DEPARTMENT OF THE ARMY
UNITED STATES ARMY AVIATION TEST BOARD
Fort Rucker, Alabama 36360

SUBJECT: Letter Report, Armed and Armored Chinook Safety-Release
and Weapon-Verification Testing, USATECOM Project No.
4-5-2010-07

INDIVIDUAL KEYING CIRCUIT
 FOR GUNNER'S INTERCOM
 IN UH-1B, D HELICOPTERS

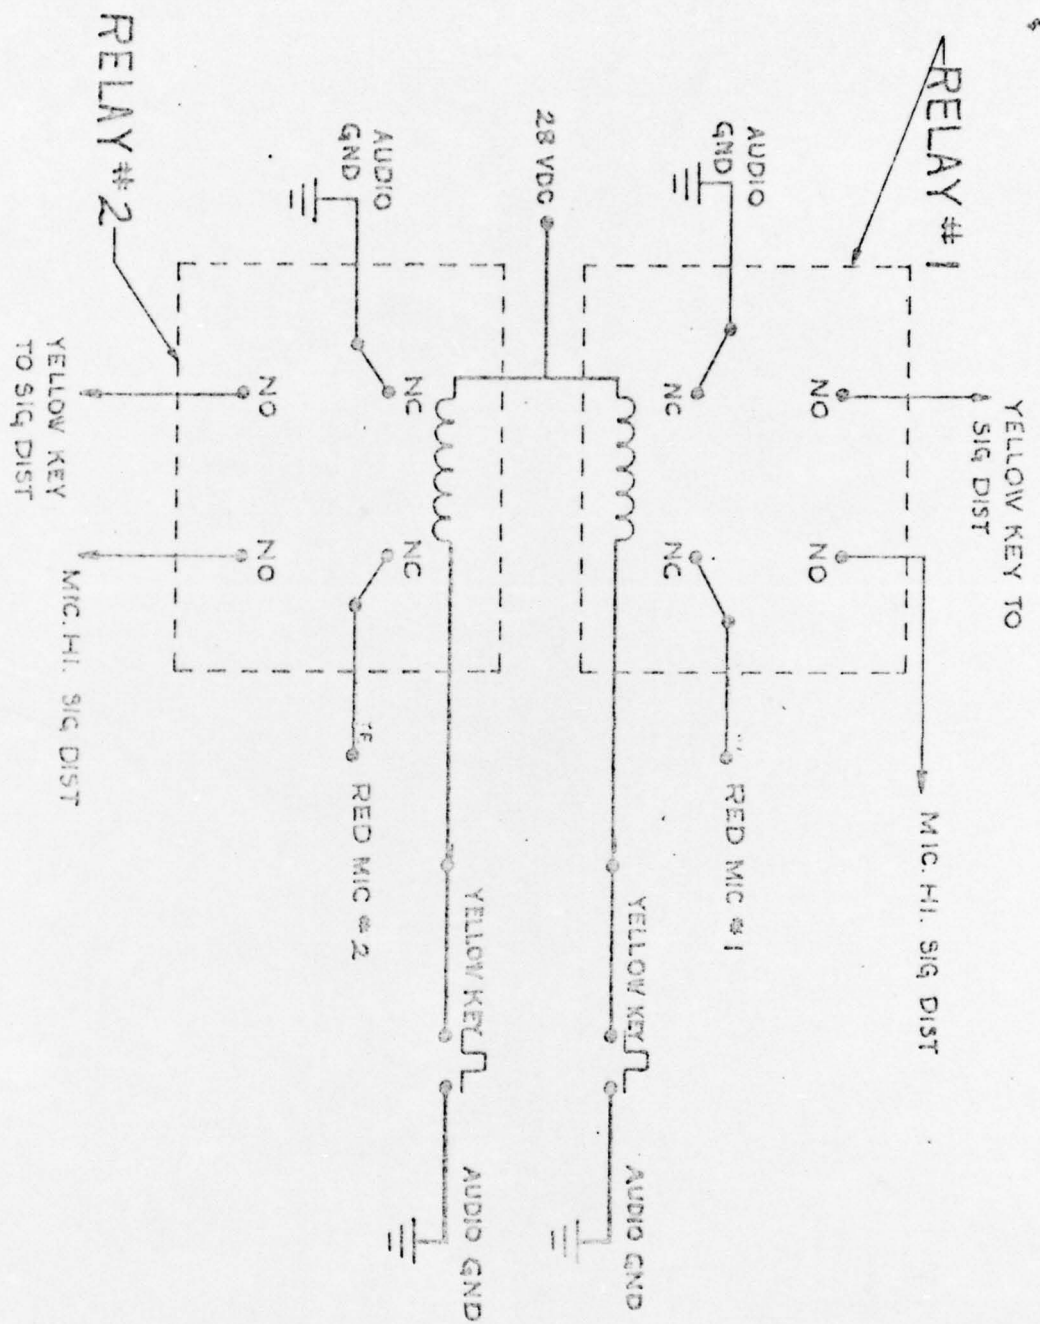
the helicopter, could not be achieved using the standard Army APH-5 helmet. An APH-5 helmet was modified with ear protector muffs, Model ASP-184, manufactured by David Clark Co., Inc. and with a directional microphone, FSN 5965-680-9798. The loss of communication between the gunners and other crewmembers is caused partially from both gunners using a common signal distribution amplifier. As a result, when one gunner "keyed" to talk, the other gunner's microphone was also energized, thus picking up twice the ambient noise (wind, rotor, transmission, engine, etc.) and causing an impedance mismatch to the amplifier. To eliminate keying of both microphones by one gunner and to make communication possible, a miniature 28 v. d. c. relay, FSN 5945-837-5318 (Incl 1) was installed in series with each gunner's microphone and key line to permit individual keying by each gunner.

d. Tests of armament subsystems in CH-47A helicopter revealed the same communication problems; and although no extensive investigation was made, the UH-1B/1D fixes are equally applicable to the armed CH-47A helicopter.

c. The installation of the relays in series with each gunner's microphone line makes communication possible from the gunners to other crewmembers.

6. Conclusions. It is concluded that communication problems can be significantly reduced by the construction of a sound attenuating helmet with a highly directional microphone and installation of the miniature 28 v. d. c. relay.
